**APPLICATION FOR PERMISSION  
UNDER SECTION 16 OF  
THE TOWN PLANNING ORDINANCE  
(CAP.131)**

For Official Use Only 請勿填寫此欄	Application No. 申請編號	A/NE-KTS/495
	Date Received 收到日期	17 MAR 2021

Proposed Temporary Shop and Services for a Period of 5 Years

**1<sup>st</sup> Further Information**

Drawing No. **PLAN 1**  
Ver. 01

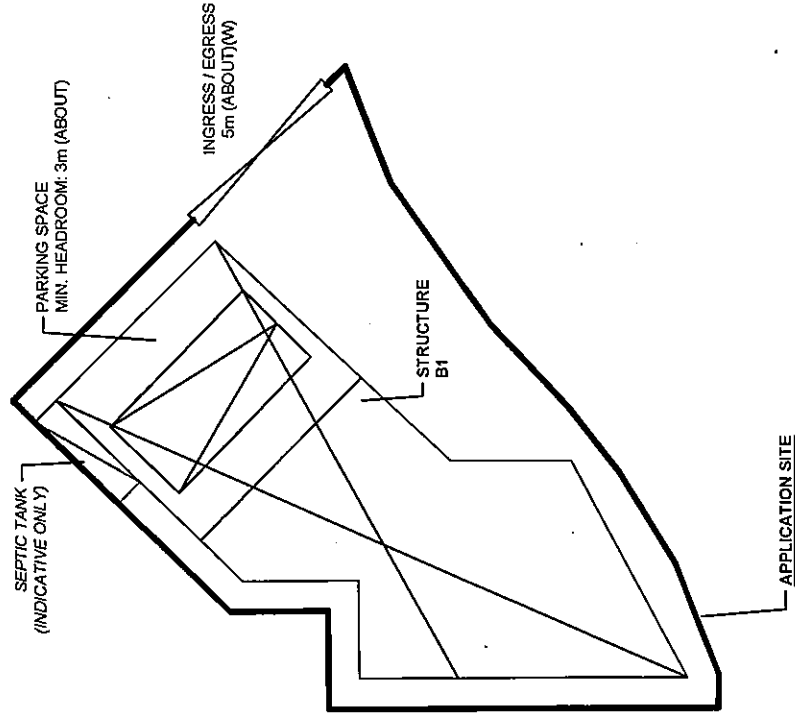
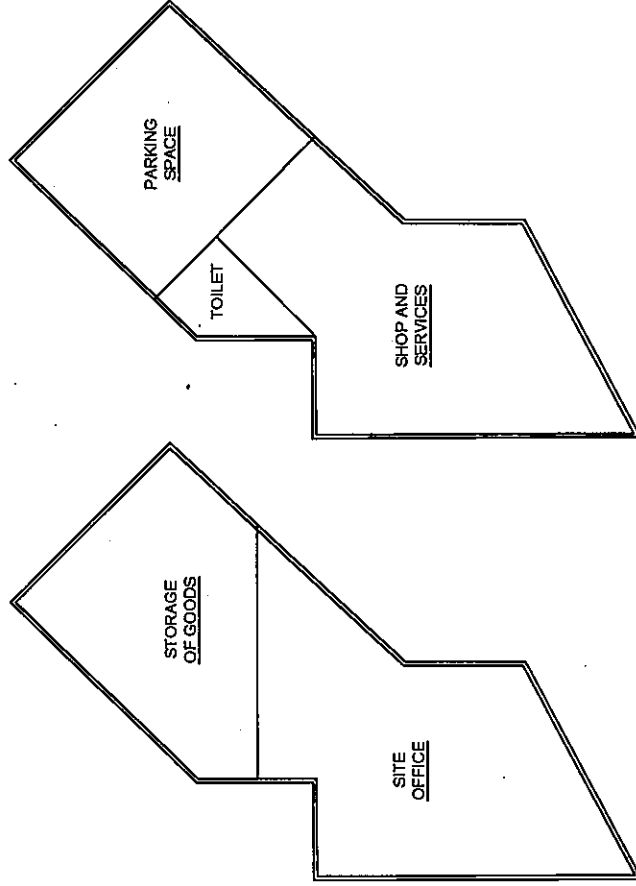
- (i) Only private car will access the Site. Light, medium or heavy goods vehicles, including container tractors/trailers are prohibited to be parked/stored on or enter/exit the application site (the Site) at any time during planning approval period. Private car is deployed for transportation of goods to support the operation of the proposed development.
- (ii) Toilet and septic tank system are proposed at the Site for sewage disposal. It is approximately 20m north of the nearby watercourse (Plans 1 and 2).
- (iii) It is noted that some existing small fruit trees are located at/near the north-eastern site boundary which is closed to the proposed ingress/egress. However, due to various issues such as:
  - The existing shallow soil depth has limited healthy tree growth; and
  - Relocation of the ingress/egress will reduce space for maneuvering of vehicle within the Site.

- (b) to note the comments of the Chief Town Planner/Urban Design and Landscape, Planning Department as follows:
  - (i) noting that some small fruit trees are located at/near the north-eastern site boundary which is closed to the proposed ingress/egress, the applicant should consider relocating the proposed ingress/egress to the existing site entrance at south-eastern side of the Site where feasible for better tree preservation; and

Therefore, transplantation or preservation of existing fruit trees is not technically feasible.
